I have the honour to inform you that the original design and estimate of the Museum provides for kapchas & lime plaster to the wall above the circular lintel carrying the dome.

Museum Building

REFERENCE No E 161 of 1925.

PLAN OF MUSEUM

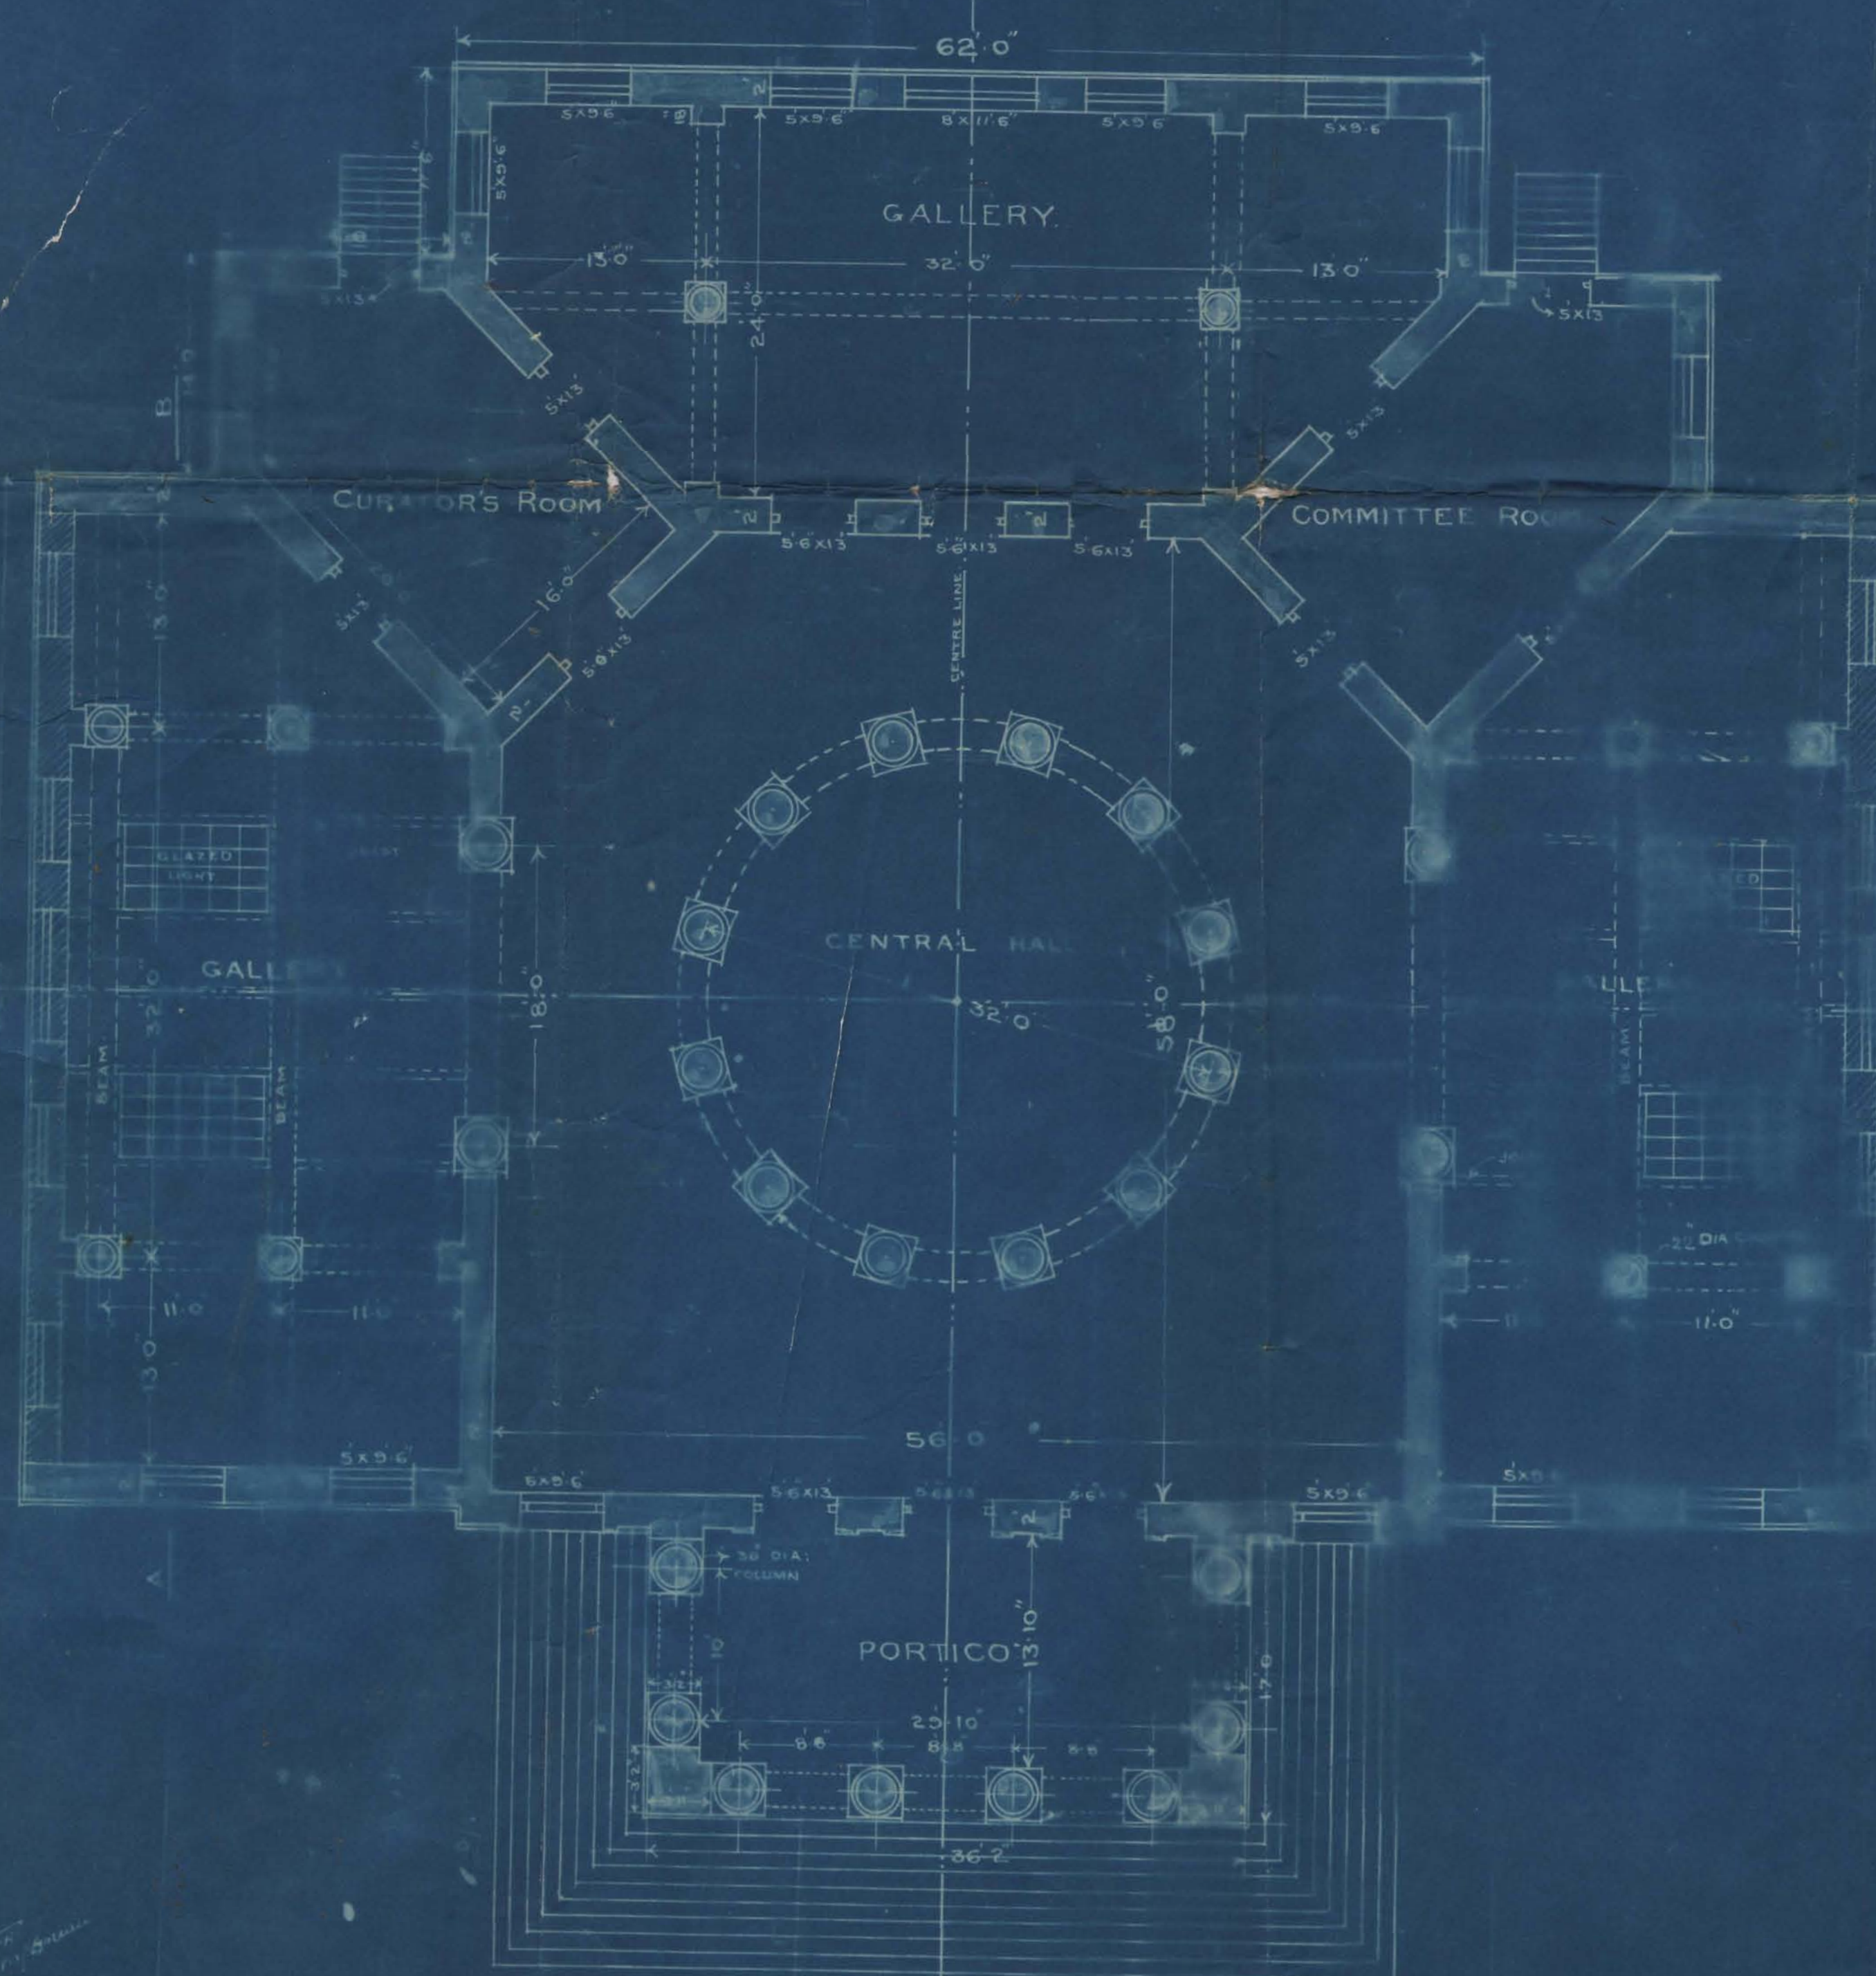
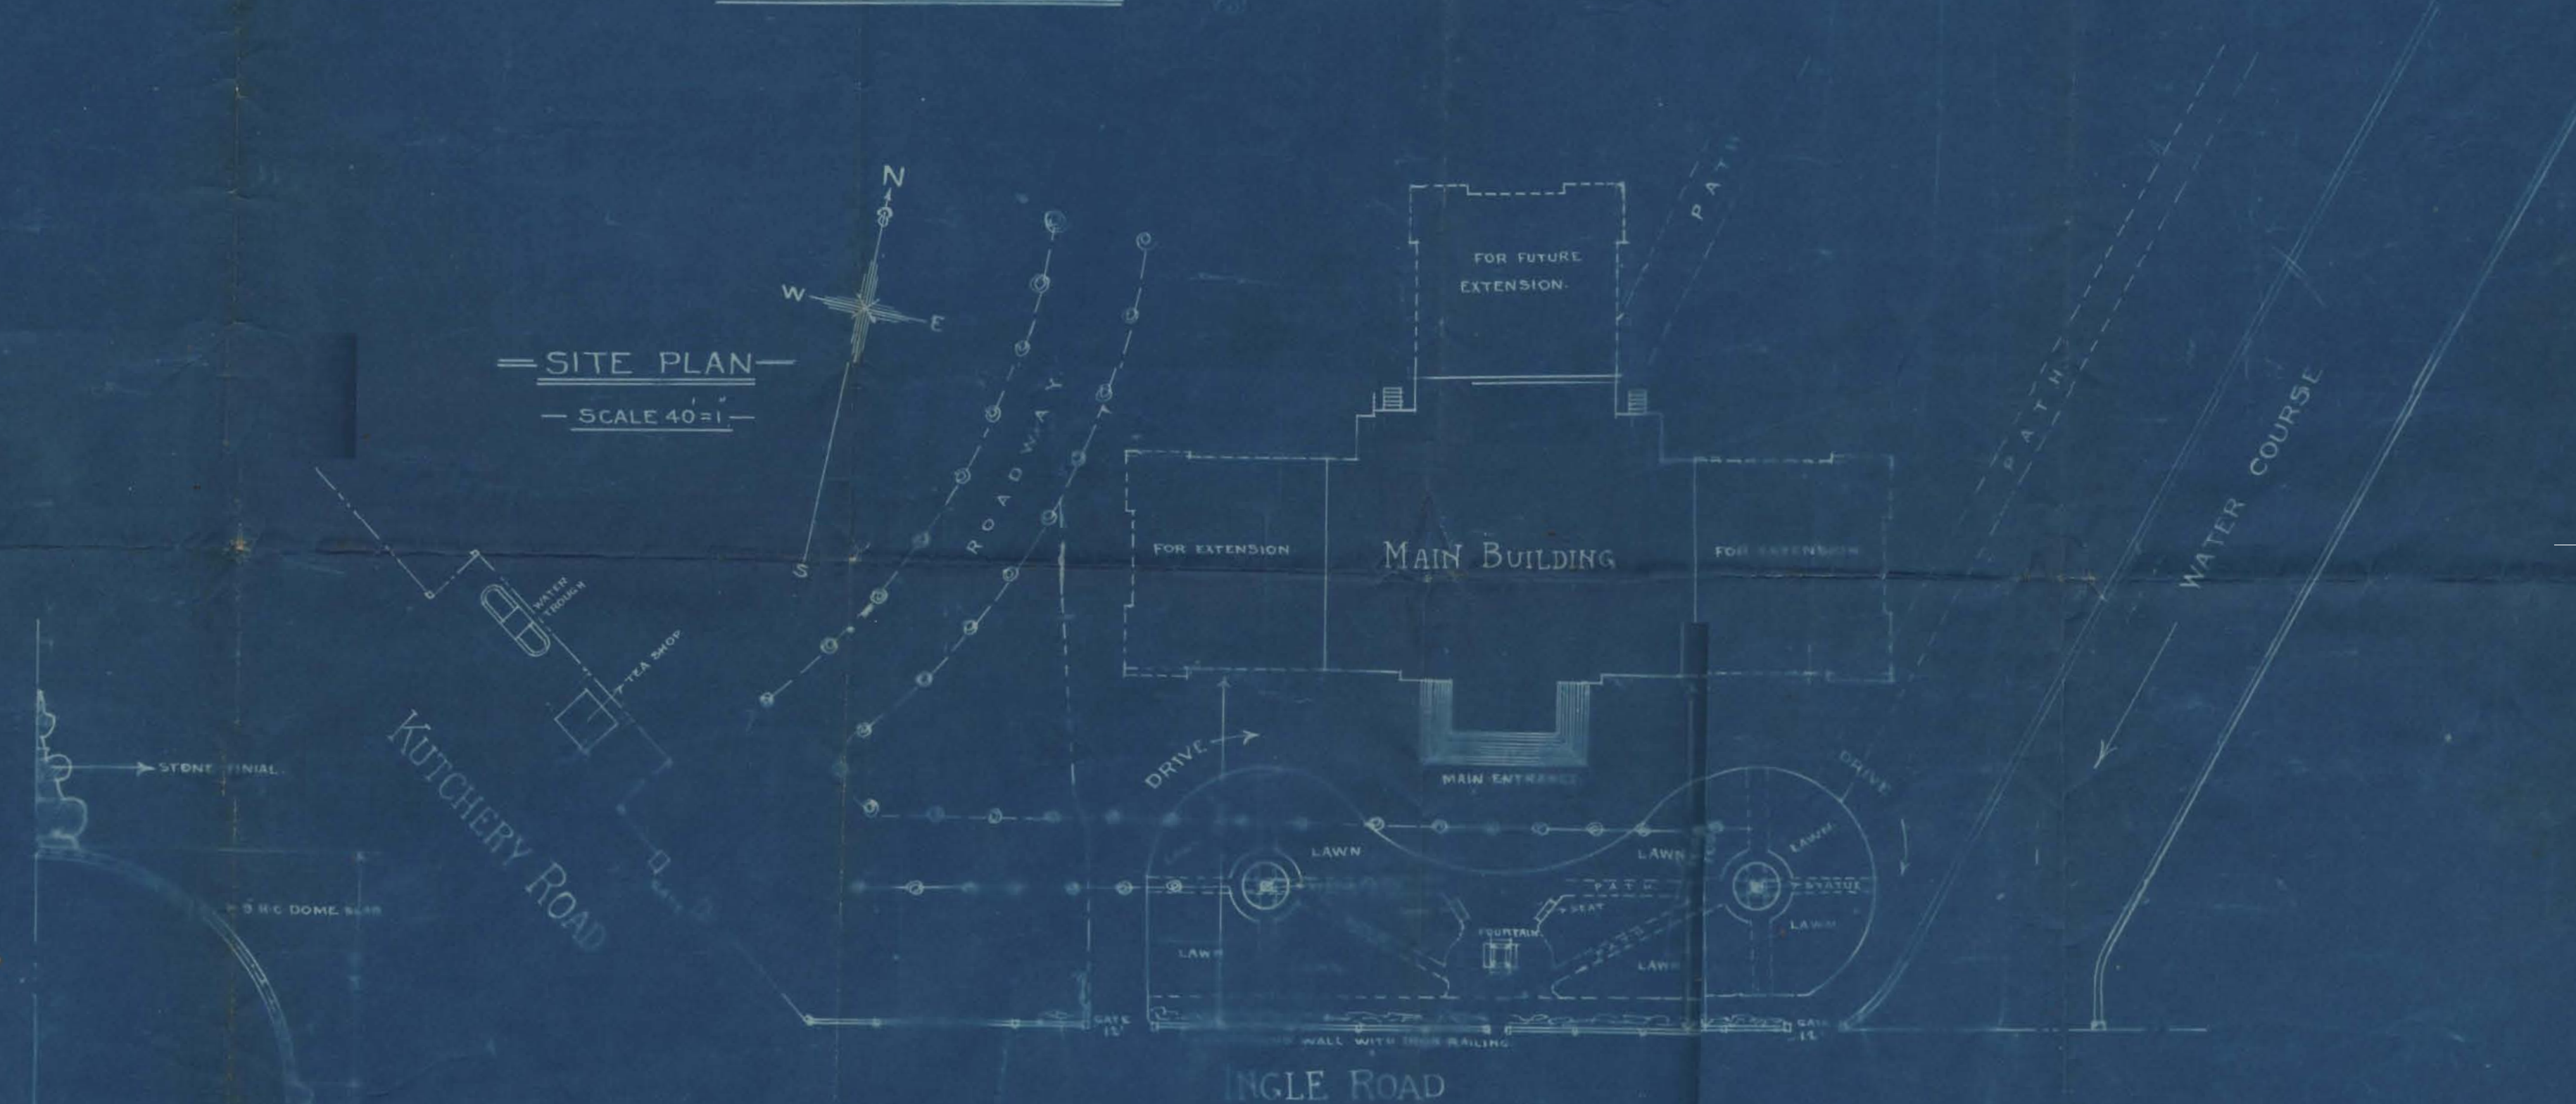
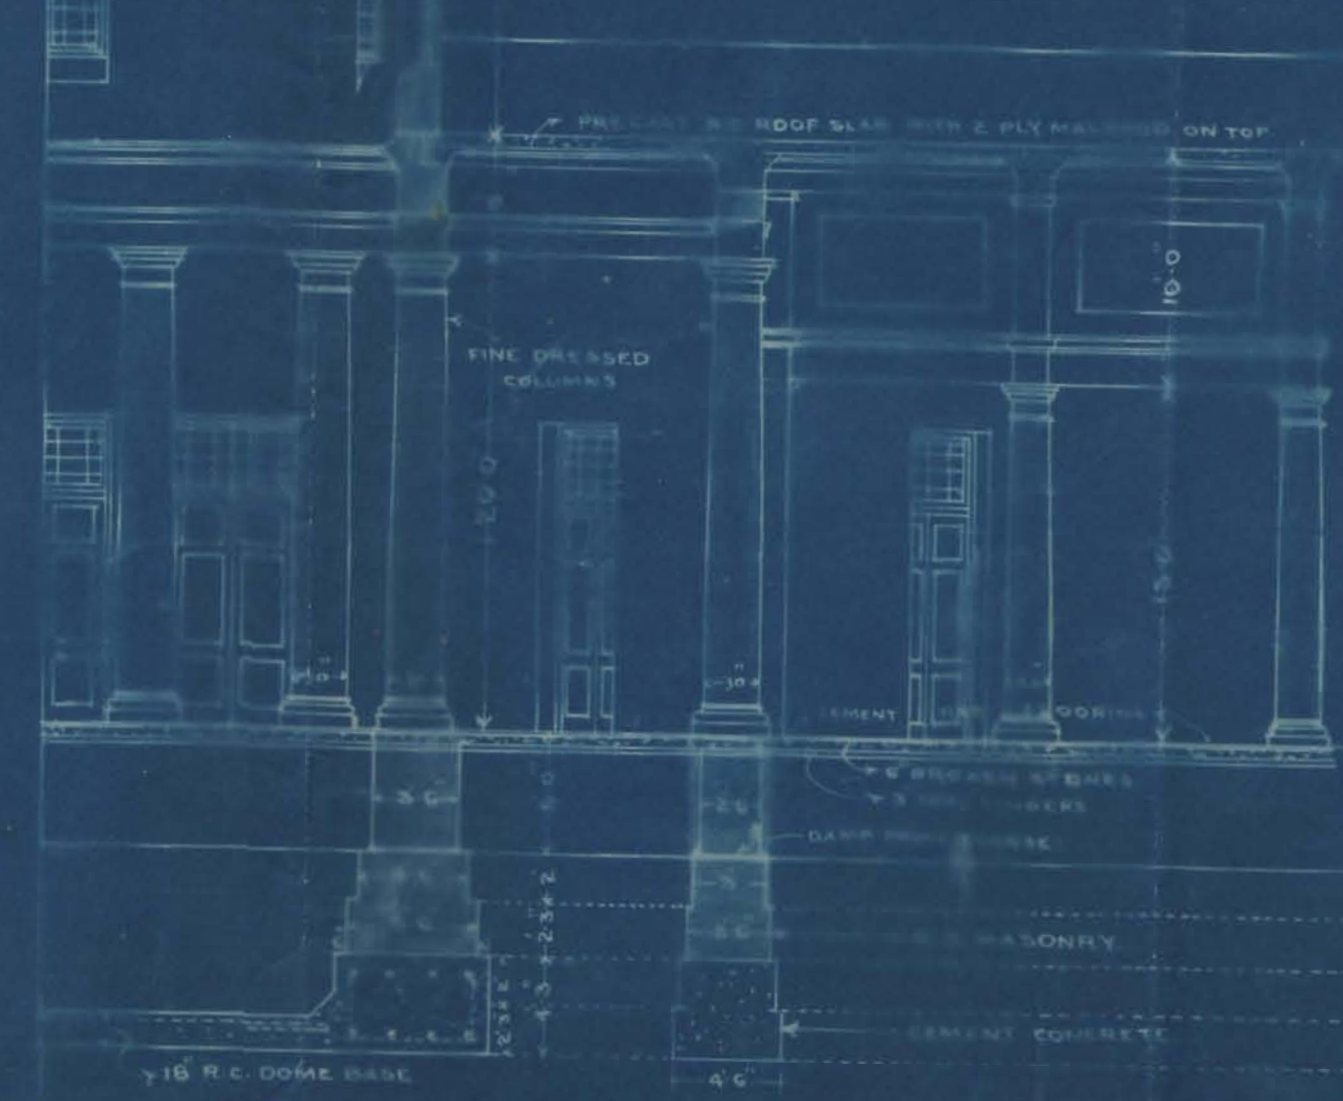
I have the honour to inform you that the original design and estimate of the Museum provides for kapchas & lime plaster to the wall above the circular lintel carrying the dome.

In a monumental building like the museum, kapcha work at a place like this will appear incongruous. I therefore propose to change this item into dressed stone on both the sides with circles in relief as shown in the accompanying blue print marked A.

For similar reasons I also propose to change Animar dressed on one side & plaster inside to fine dressed masonry dressed on both the sides from roof to main cornice of dome base.

The proposed changes will entail an excess expenditure of Rs.1037 as per estimate attached herewith.
